PROJECT: Tropical Jones (update #5)

CITY OF LAS VEGAS		DATE:
INTER-OFFICE MEMORANDUM		October 17, 2012
TO: Land Development Services Department of Public Works		FROM: Albert Sung, P.E. Flood Control Project Engineer Department of Public Works
SUBJECT:	Drainage Study for:	COPIES TO:
	Tropical – Jones (Update #5)	Taney Engineering
Cross Streets:	SWC of Jones Blvd. & Tropical Pkwy.	William Lyon Homes
File Number:	F:\Depot\DSMemos\DS3911J.doc	Bart Anderson, P.E., DevCo
Parcel Number:	125-26-704-001 to -003 and more	CCDDS
Zoning Action:	ZON-6928; SDR-6929; VAR-6930; WVR-6931; TMP-8628 & VAC-8986	
FEMA Flood Zone	YES	NO X
Proposed Storm Drain	YES	NO X

8th Submittal: Update #5 to revise roll curb section and to raise minimum interior street slope to be 0.6%

**UPDATE #5 TO THE
TECHNICAL DRAINAGE STUDY
FOR
*TROPICAL - JONES***

GRADING DETAILS & CROSS SECTIONS

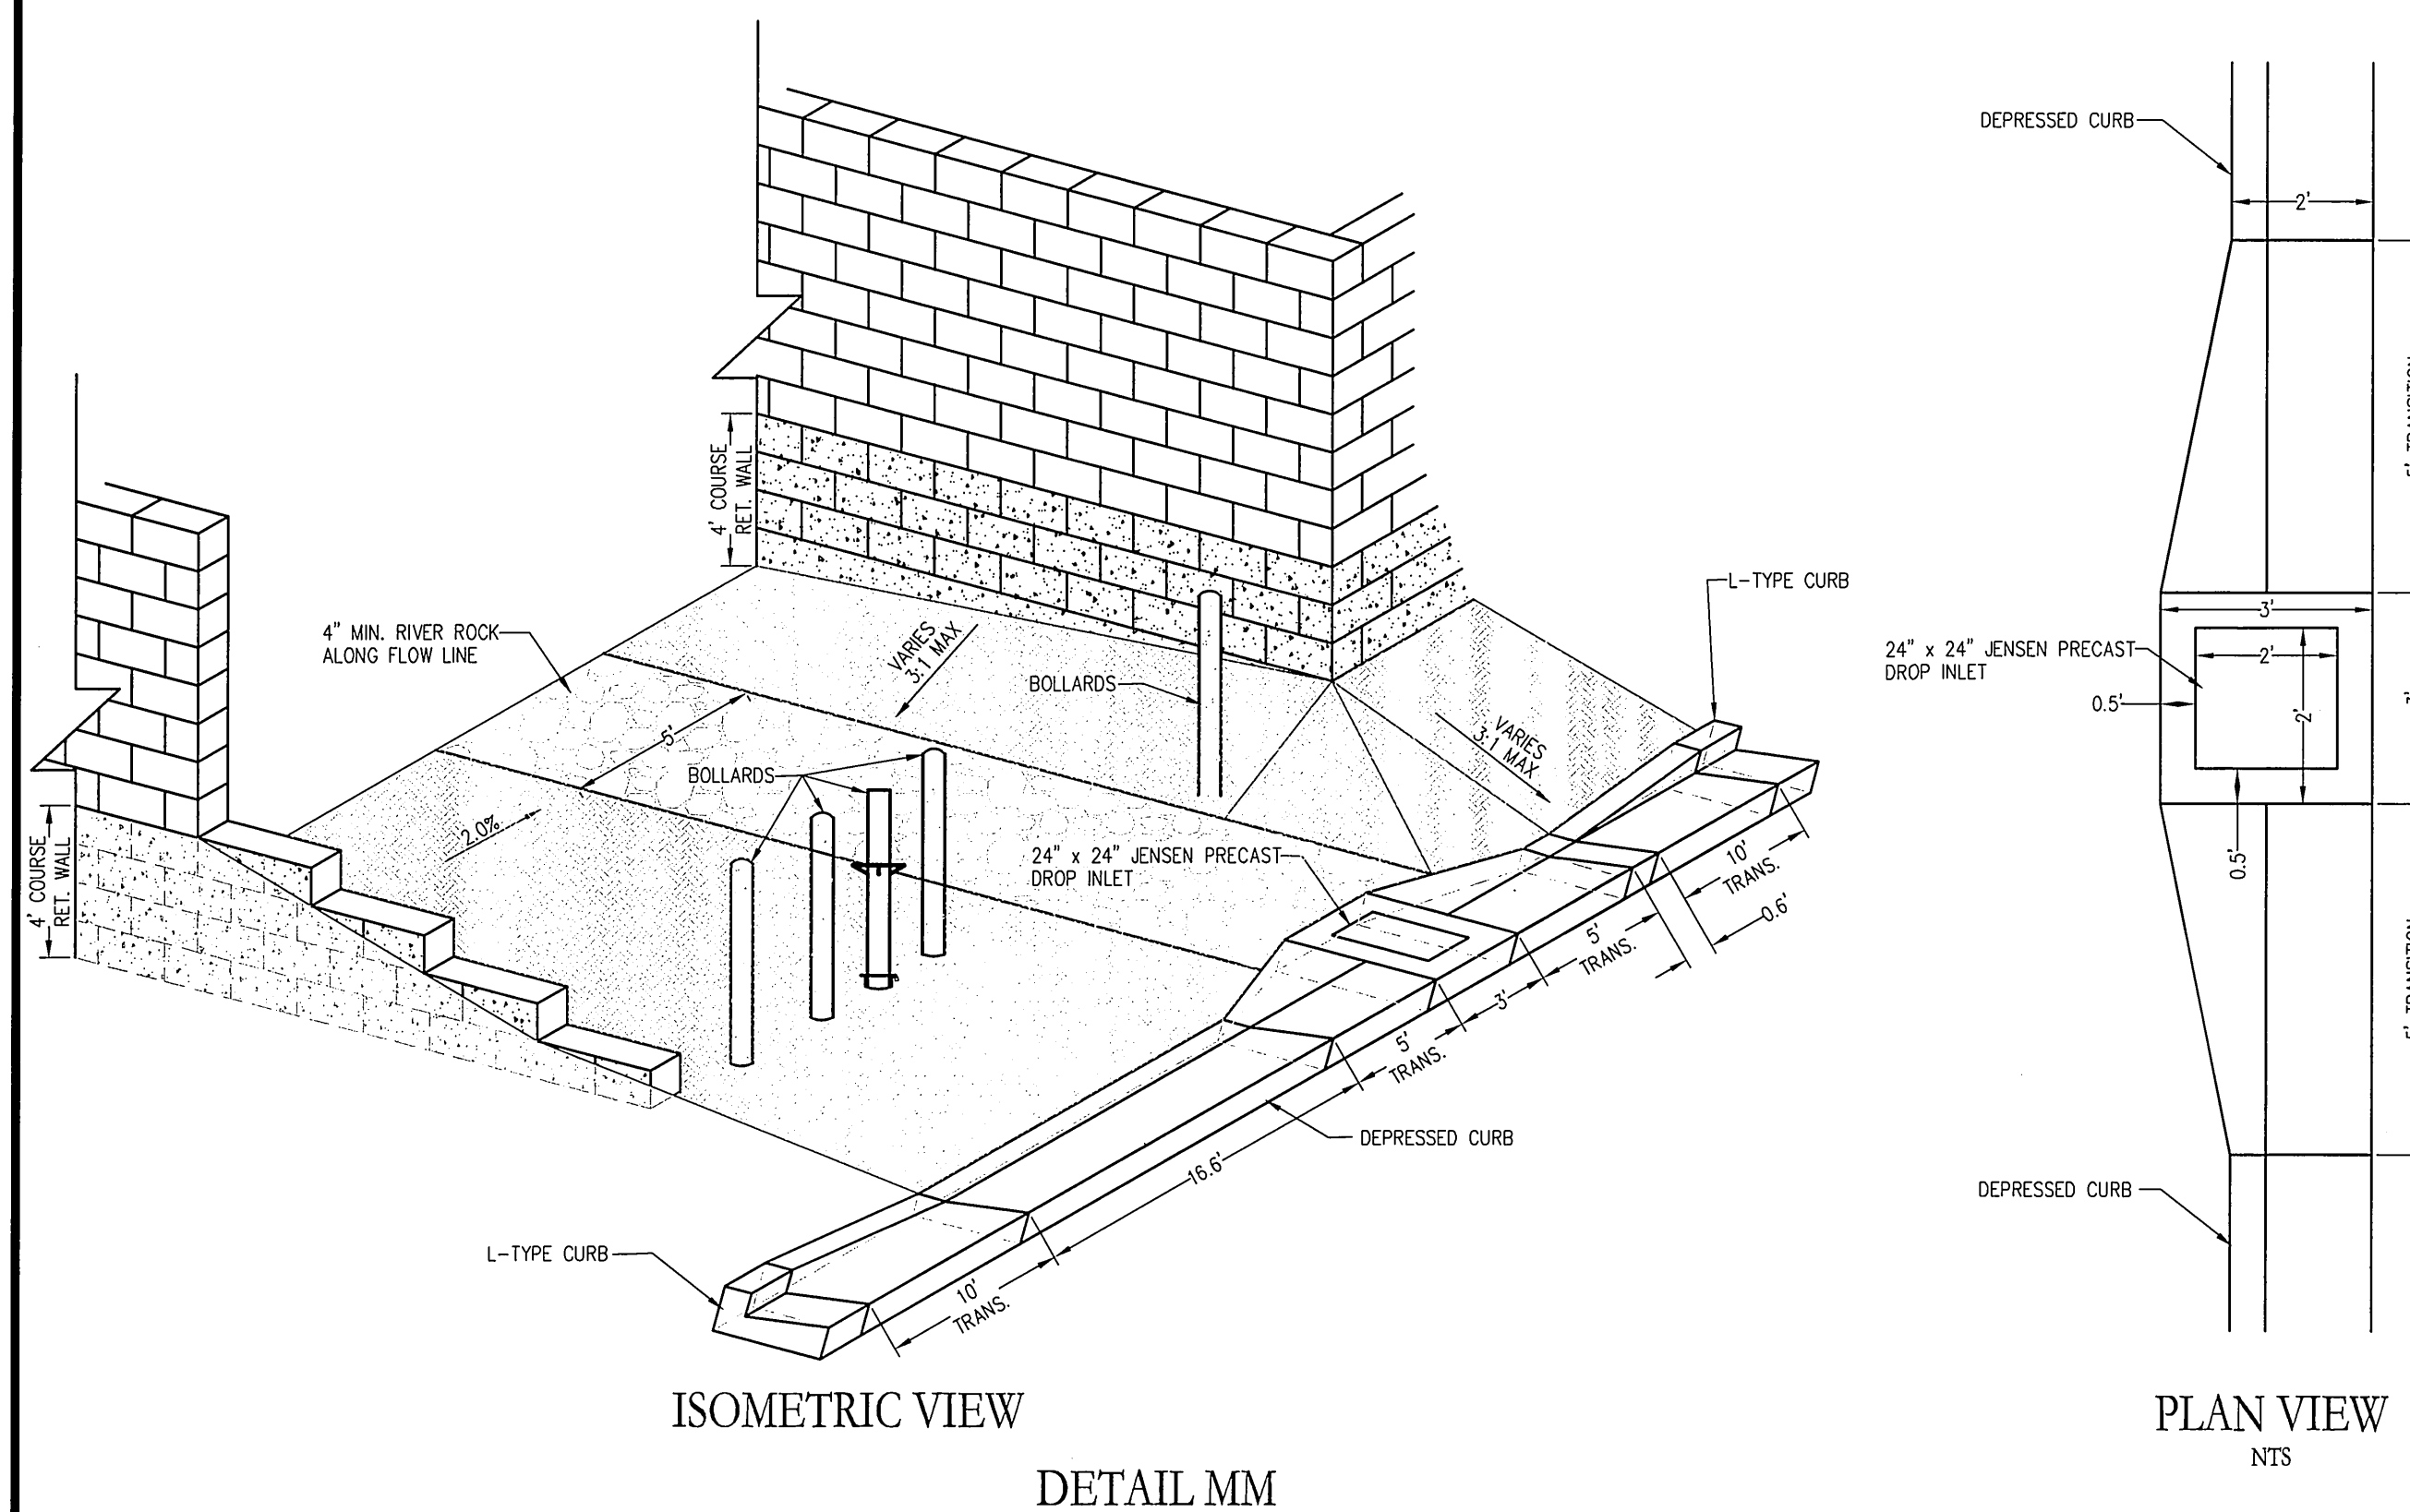
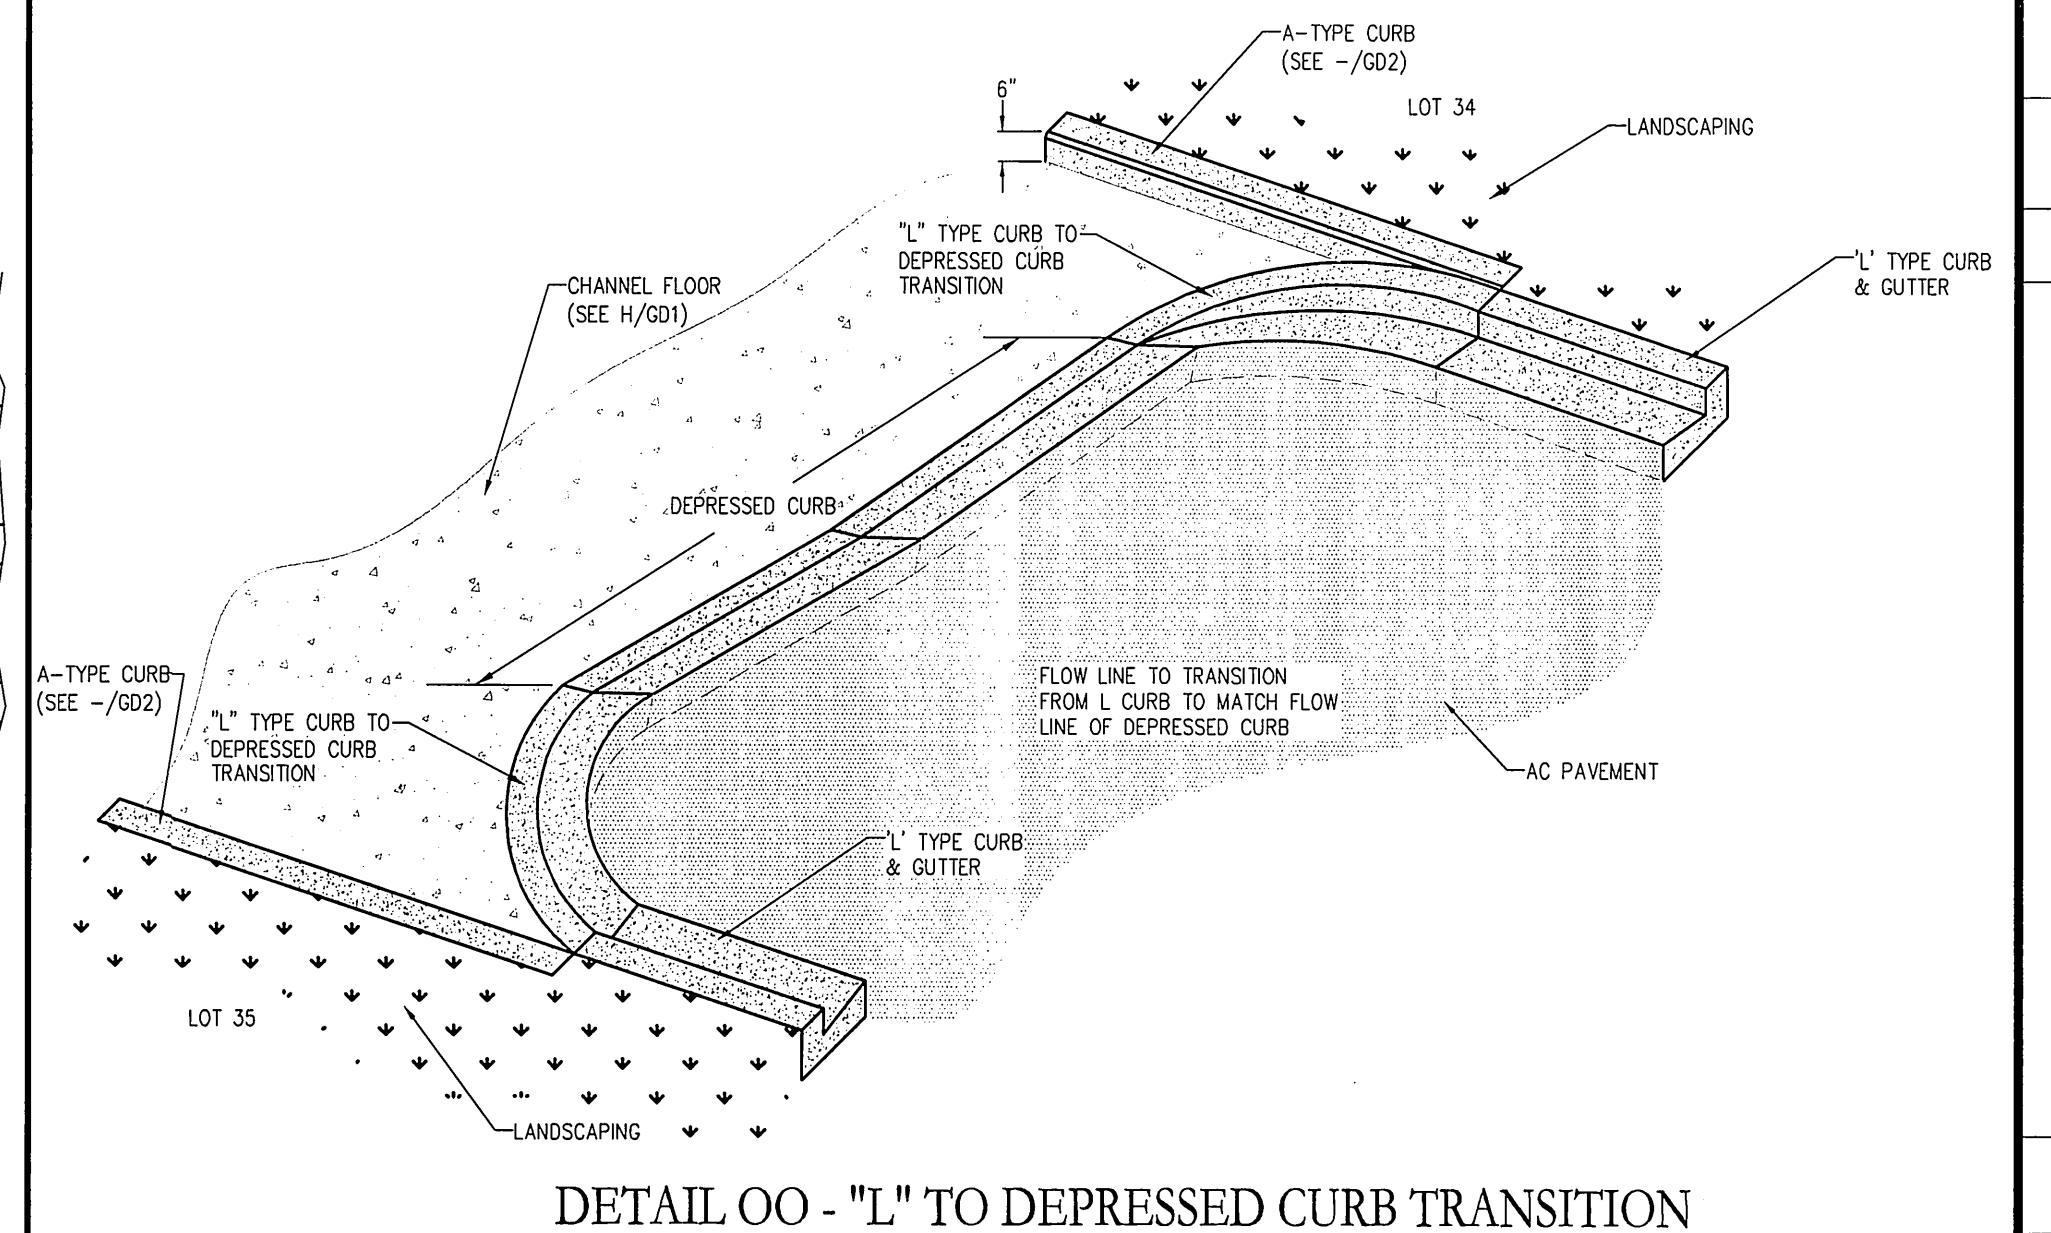
1. The original approved monolithic roll curb with cut-off wall has a function to prevent drainage seeping under the roll curb (if the cut-off wall is absent) and eventually damaging the pavement in the street section. With the proposed revision, a leak space is essentially created between the standard roll curb and the cut-off wall beneath, thus defeating the purpose of the modified roll curb. A variation of installing the cut-off wall behind instead of beneath the roll curb is more appealing. The City is also open to other acceptable alternatives. Please review and address in the next submittal.

1. The cut off wall under the 30" roll curb on Bronco Street has been revised. Presently it is shown as a monolithic pour under the curb. This is difficult and costly to construct. It is being revised to be 18" deep by 8" wide under the outside edge of the roll curb. Details B, P, and Q on Sheet GD1 have been revised, Sheet GD1 is included in Appendix C.
2. The onsite grading has been revised to have a minimum slope of 0.60% instead of 0.40%. The street sections have been revised with the results being shown below in Table A. The section locations are shown on Figure 6, located in Appendix C. The street calculations are included in Appendix B.
